Design Problem No. 1

Dean L. Sicking, Ph.D., P.E.
2004 Roadside Safety Workshop
June 23-24, 2004

Midwest Roadside Safety Facility

Treatment of Ponds Near Edge of Clear Zone

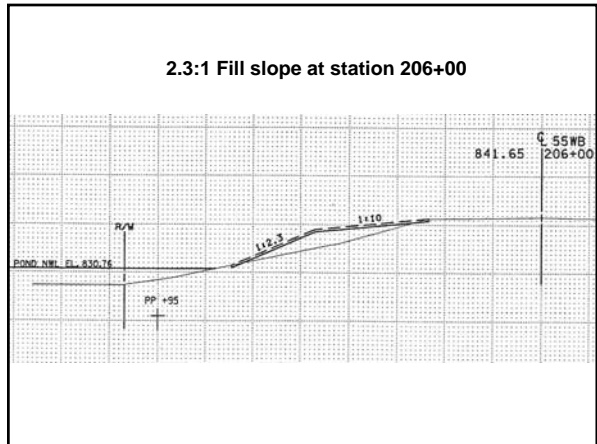
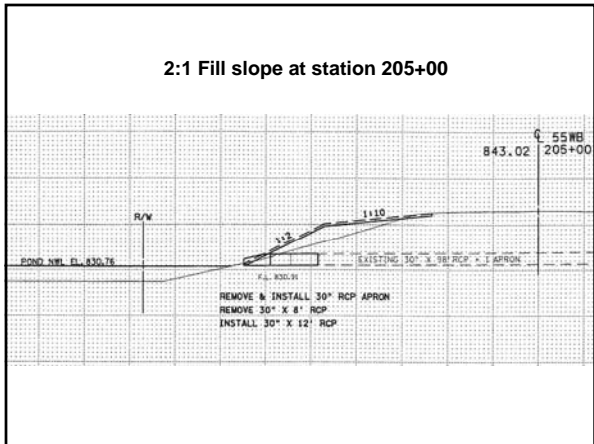
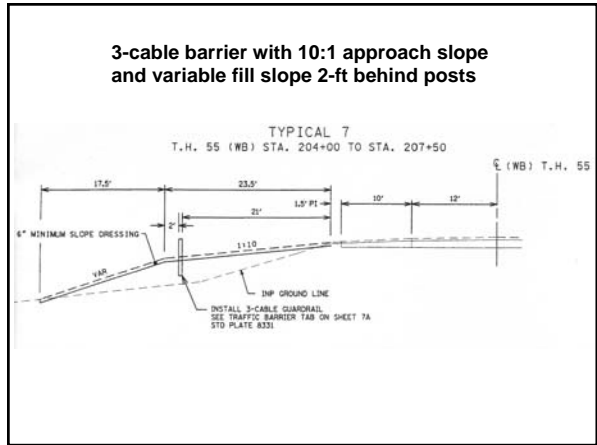
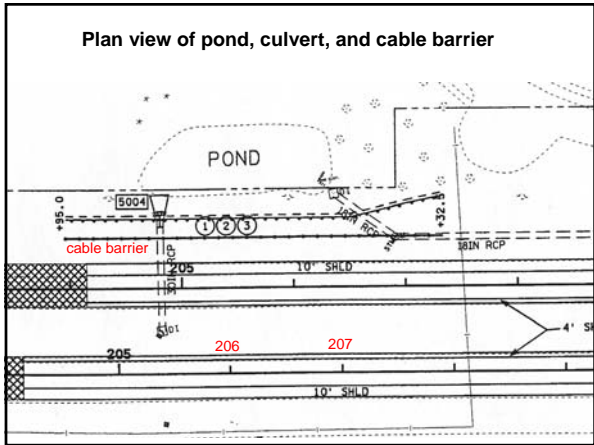
- Facts
 - 6-ft deep pond near and/or within clear zone
 - culvert at upstream end of pond
 - three cable barrier used to protect entire obstacle, including portions outside of clear zone
 - 10:1 approach slope to cable barrier
 - slope, varying from 2:1 to 5:1, begins 2-ft behind cable barrier posts
 - no accident history

- **Comments**
 - three cable barrier incapable of redirecting 2000P vehicle impacting at TL-3 condition of NCHRP 350 when installed adjacent to 1.5:1 slope
 - TL-3 approved, strong-post, W-beam design variations exist when placed near or directly on 2:1 fill slope

- **Conclusions**
 - could conduct benefit-cost analysis to determine whether entire hazard required protection
 - extending protection to include entire hazard is reasonable and appropriate due to small increase in guardrail length
 - if MnDOT treats hazards entirely outside of clear zone, agency wide policy should be adopted
 - potential tort risk associated with inconsistent application of clear zone principles

- Cable guardrail may function in this application, but research not yet complete
- Simulation study indicates cable barrier should provide acceptable performance when placed 3' in front of slope break point and post spacing reduced to 4'
- W-beam guardrail with 7' posts on 3'-1.5" centers placed at the slope break point is an NCHRP Report 350 approved alternative
